NEW YORK CITY DEPARTMENT OF
DESIGN + CONSTRUCTION

ADDENDUM NO. 3

PROJECT: SE-807, Preliminary and Final Design Services for the Installation of Storm and Sanitary Sewers on 20th Avenue, between 126th Street and U.S. Bulkhead Line Area and Water Main Replacement in College Point Boulevard, between 11th and 22nd Avenues, Borough of Queens

Figure 1 – Limits of Topographic Survey

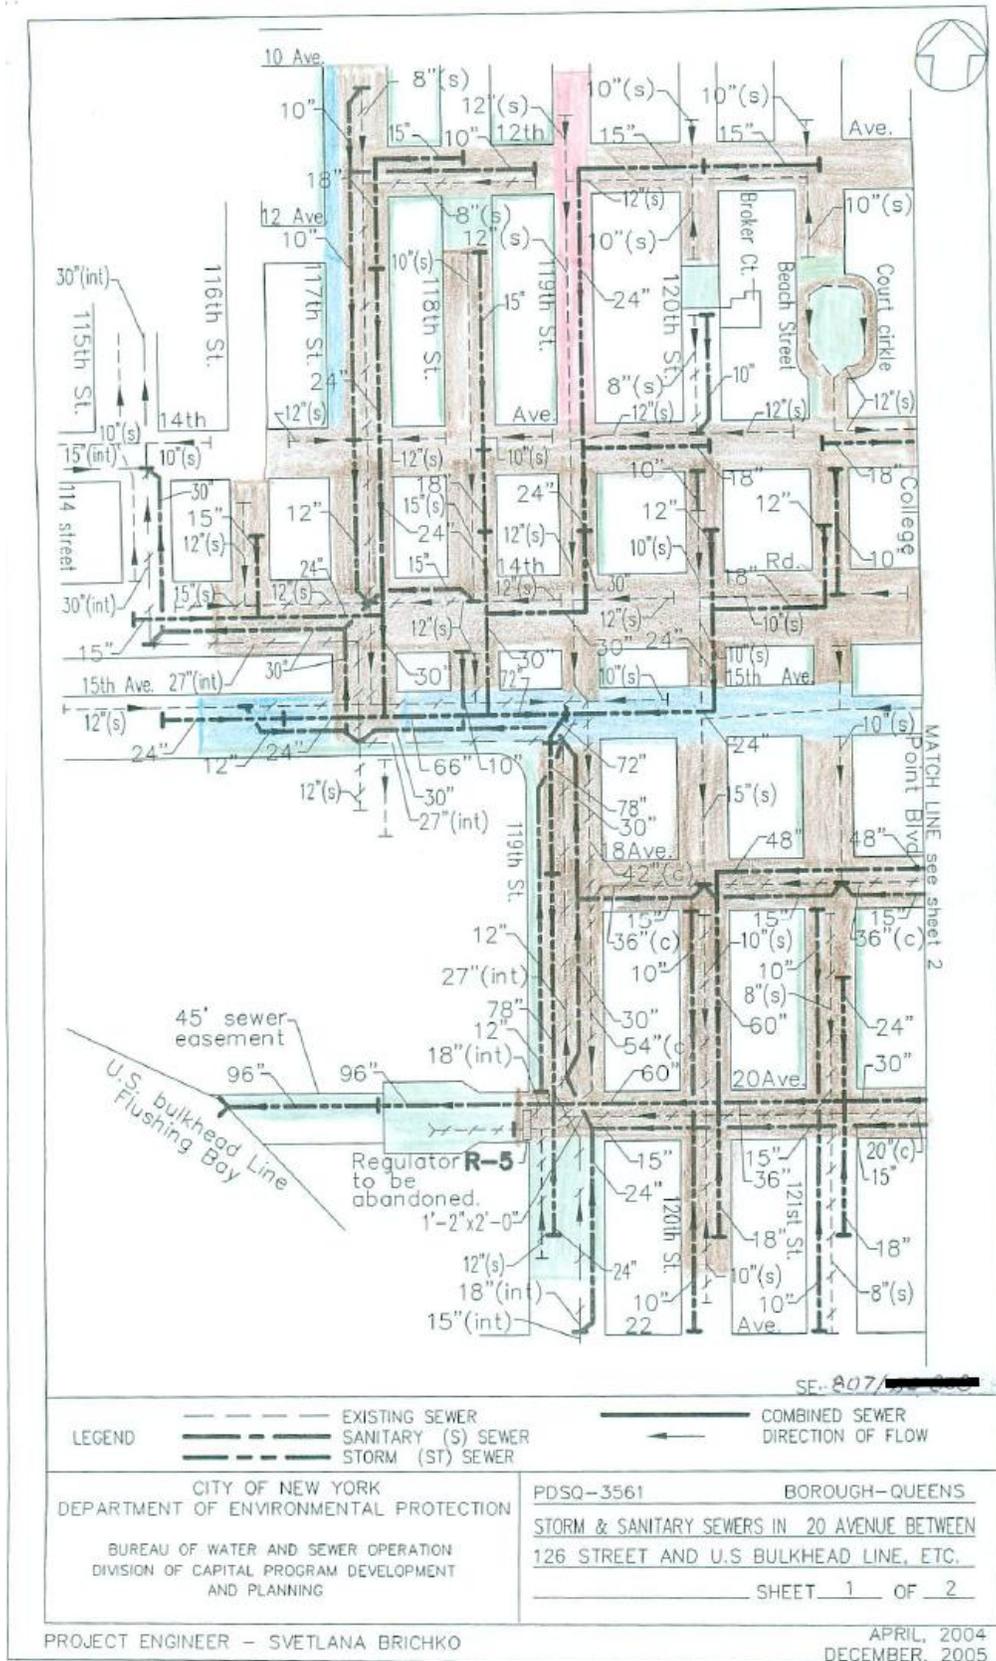
- A. The Consultant shall perform the following Preliminary Design Tasks in accordance with the General Requirements (GR).
- 1. Topographic Survey: GR Section 4.2

The Consultant shall use the survey control information previously prepared by others and perform Topographic Survey for the locations listed below, within the limits shown on Figure 1 on the following page.

- 115th Street from intersection of 14th Avenue to intersection of 14th Road.
- 116th Street from intersection of 14th Avenue to intersection of 14th Road.
- 117th Street from intersection of 10th Avenue to intersection of 14th Avenue
- 121st Street from intersection of 14th Avenue to intersection of 14th Road.
- 119th Street from intersection of 20th Avenue to intersection of 22nd Avenue.
- 120th Street from intersection of 20th Avenue to intersection of 22nd Avenue.
- 121st Street from intersection of 20th Avenue to intersection of 22nd Avenue.
- 125th Street from intersection of 20th Avenue to intersection of 22nd Avenue.
- 12th Avenue from intersection of 117th Street to intersection of 119th Street.
